SERVICE BULLETIN

LG Electronics Inc.

Date of issue: 15 May. 2009

Buyer Model : 24inch Washer	
LGE Model : 24inch Washer	
Buyer Name : * . *	Effective Date : 18 May.2009
Applicable Serial No. : The Produced LOT from 18 May. 2009	
SUBJECT : The Part Exchange Method according to New Tub Cover Assembly Application	
PHENOMENON	<u>In the case of the part exchange such as tub cover and gasket, Comply with the below.</u>
<p>The Gasket Hole is applied to the product in patches since May. 2009 But It's not applied to the product produced before Apr. 2009</p> <p>So apply old gasket about the product produced before Apr. 2009 for service. On the contrary, apply to new gasket after May. 2009 by checking Whether it has a hole or not. Do service and refer to <Fig.1> on the problem caused according to the combination of parts.</p> <p>CASE 1. Only Gasket Exchange Check for the production data. And then refer to the part list of each model in <Fig.3>for service.</p> <p>CASE 2. Only Tub Cover Exchange Check for the production data. And then refer to the part list of each model in <Fig.3>for service.</p> <p>CASE 3. Only Balance Weight Exchange New b/weight can be applied to all products which old o

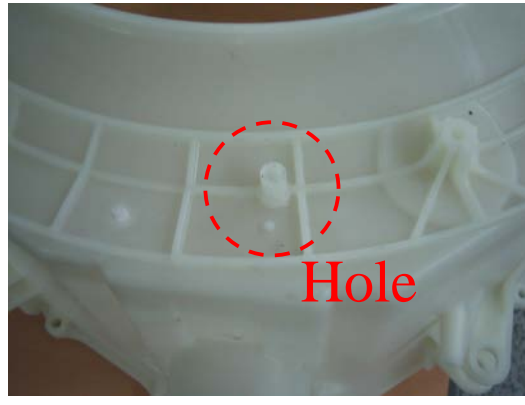
ITEM		P/No
Tub Cover Assembly	Old	ACQ33695301
	New	ACQ33695307
Tub Cover	Old	MCK38263701
	New	MCK38263703
Gasket	Old	MDS38265301
	New	MDS38265303
